RFP Title: Classical High School Campus Electrical Upgrades

Addendum #: 2

Addendum #2

Project: Classical High School 770 Westminster St., Providence, RI 02903

2 SWITCHGEAR MANHOLE PLAN & SECTION
E-502 SCALE: NTS

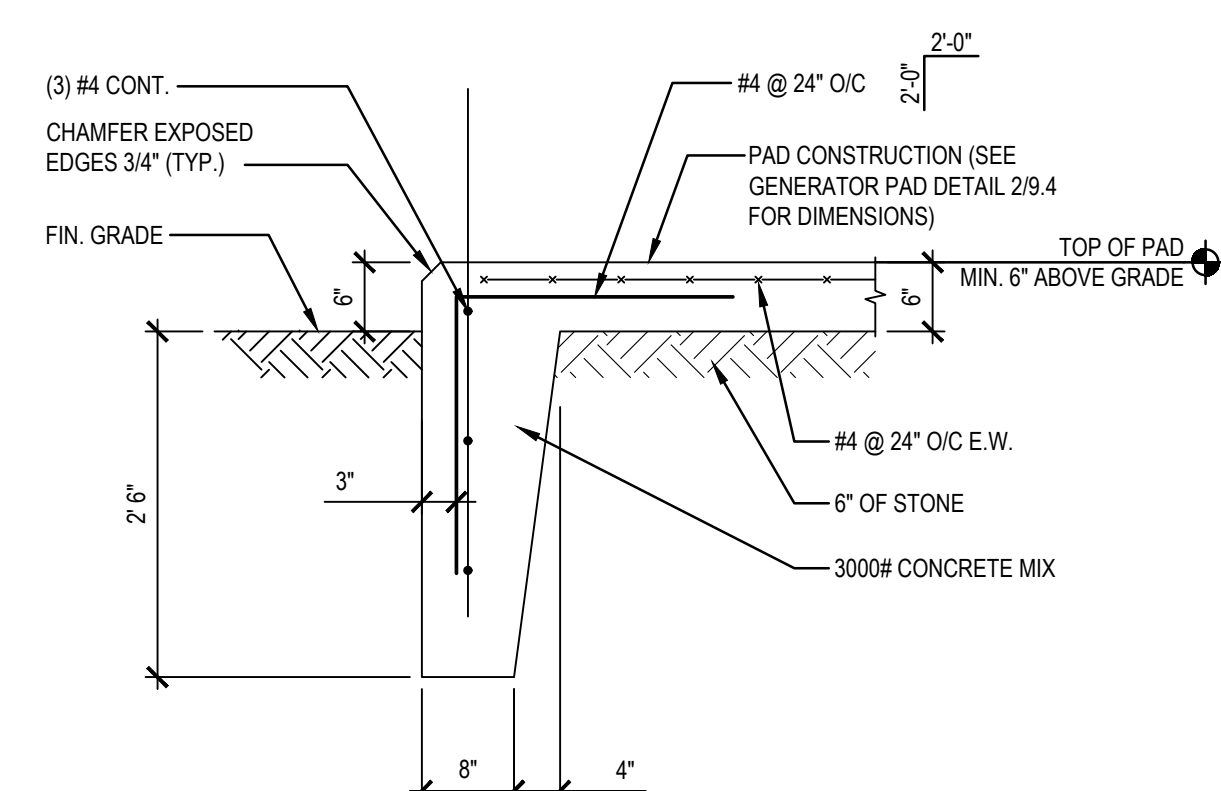
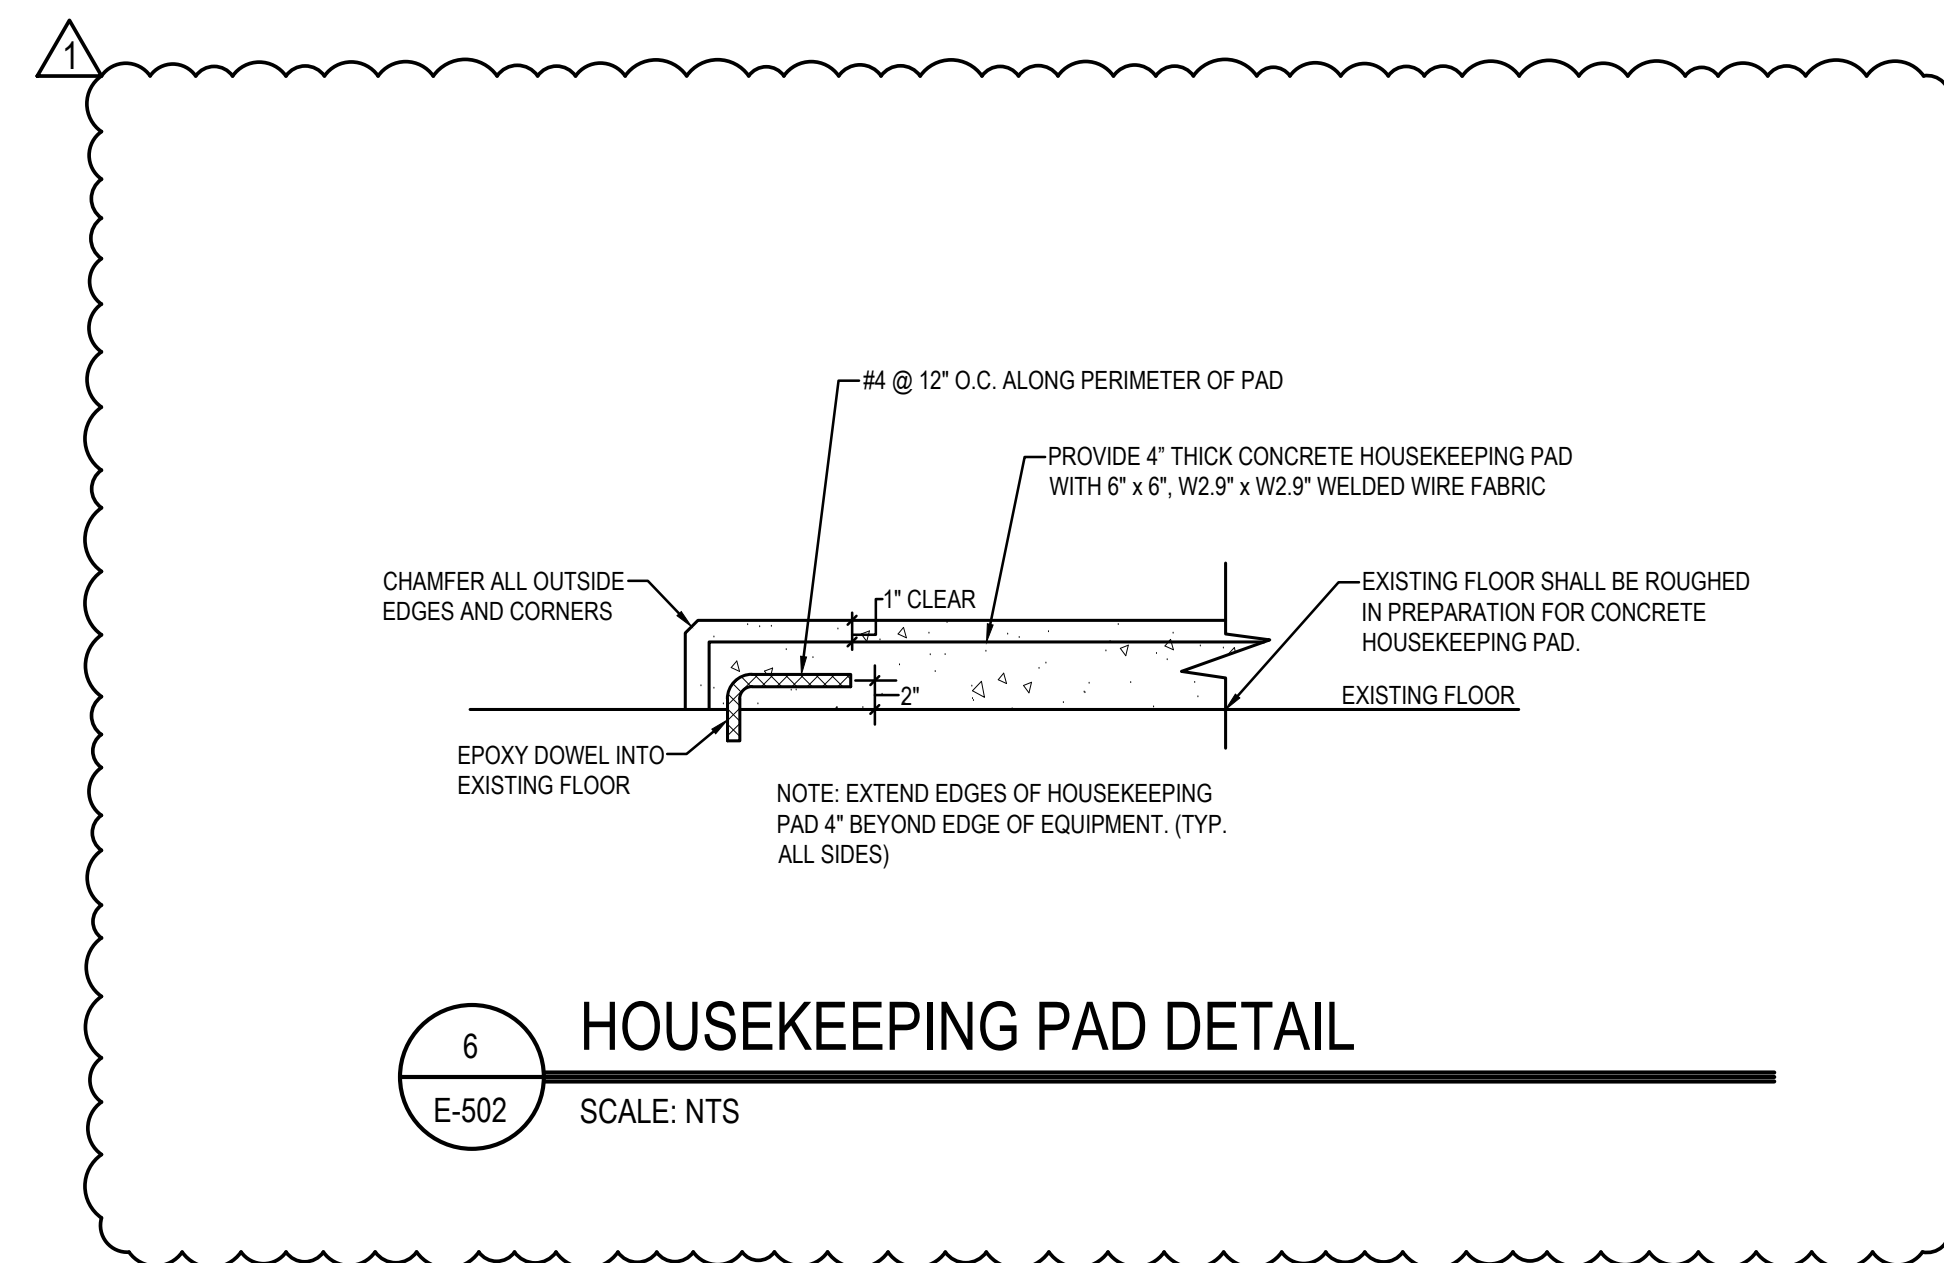
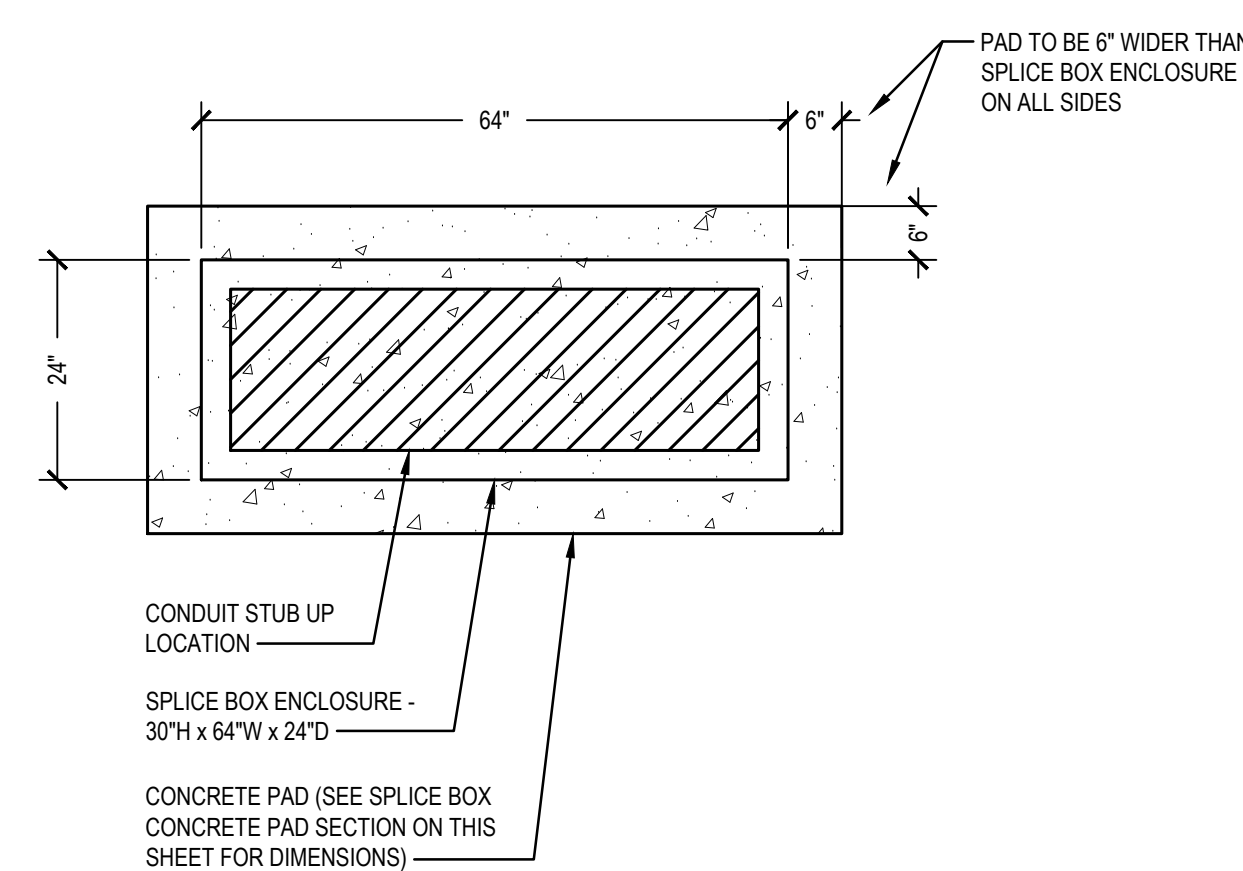
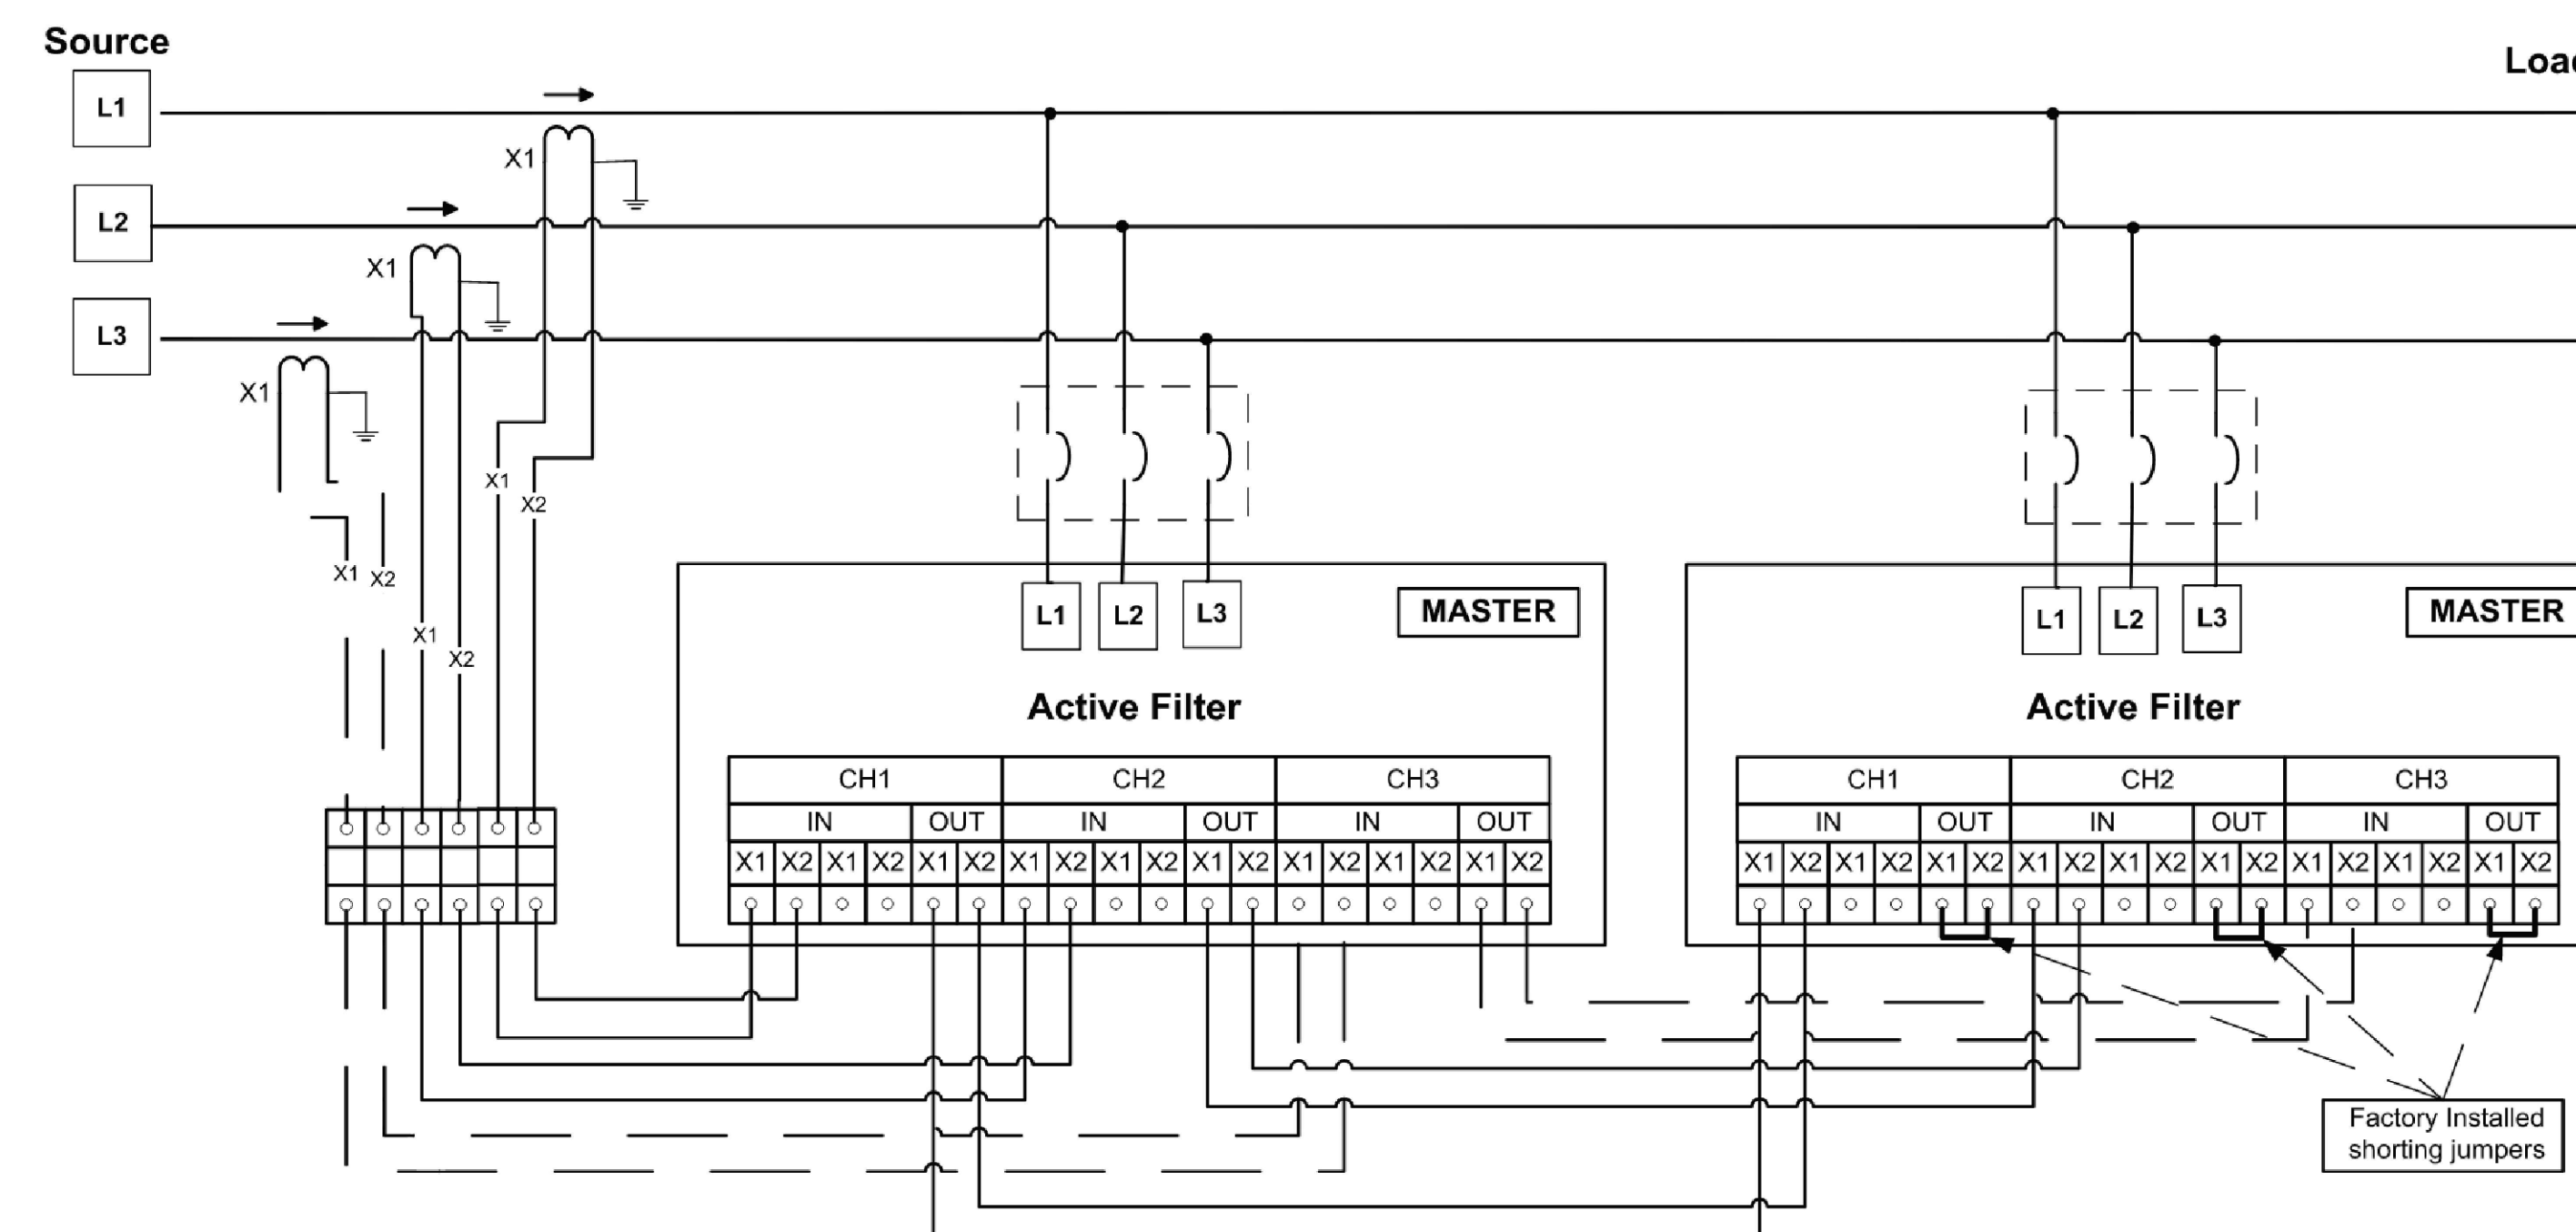
- 1. *Drawing E-101*
 - a. Identified additional scope in Building H.
- 2. *Drawing E-102*
 - a. Moved enlarged plans associated with Building 2 to sheet E-103.
 - b. Added a demolition plan of the basement of Building 1.
 - c. Added a DVR and a new 1200A panel PH1 to the new plan of the basement of Building 1.
- 3. *Drawing E-103*
 - a. Added this sheet.
 - b. Moved enlarged plans of Building 2 to this sheet from E-102.
 - c. Added Building H demolition and construction plans.
 - d. Added pullbox locations to Building 2 plans.
 - e. New housekeeping pad added.
 - f. Added new Distribution Section to **(N) SWBD-1.**
- 4. *Drawing E-502*
 - a. Added the housekeeping pad detail.
- 5. *Drawing ED601*
